## 1 Products affected

Product hierarchy no. *			Part no.	SBU	Type / Description	Customer part no.
SBU   PG	PGU	Type				
02	005	017	0000001301	See list below	Power Entry Module	EF11

## 2 Type of change

EF11					0118.2262	
creation date	created by	release date	released by	notification no.	revision	page
2015-01-19	huberth	2015-08-05	huberth			1 of 2

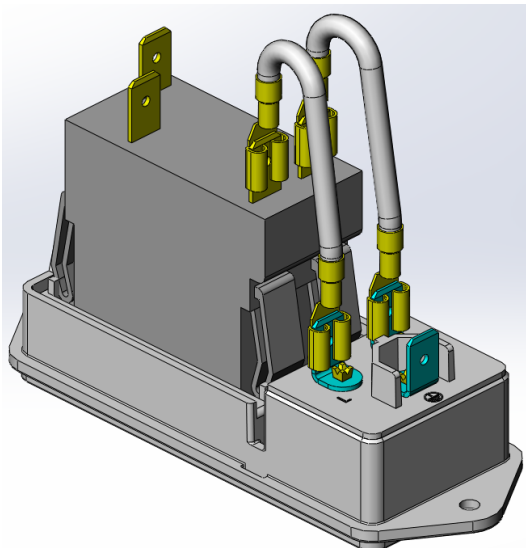
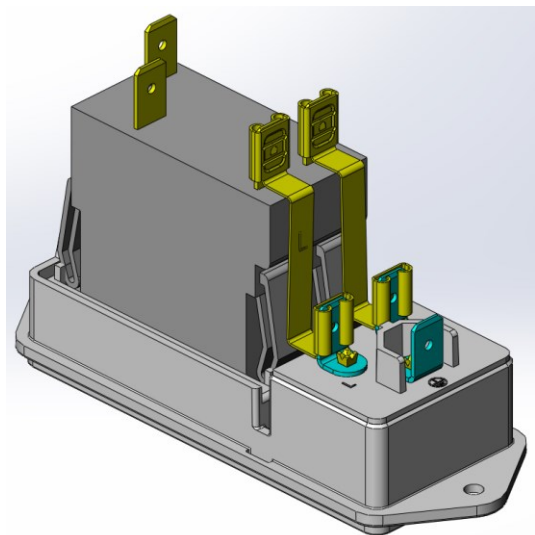
Stranded wire jumper between connector and circuit breaker replaced by a solid jumper.

Old version:

New version:

Reducing the installation depth and harmonization with other power entry modules with circuit breaker TA45.

Form: Yes New connection on back side, reduced installation depth.  
Fit: Yes The installation depth is reduced by approx. 20 mm.  
Function: No This is a non-functional change.  
Production Site: No There is no change of the production site.  
Product Label: No There is no change on the label.
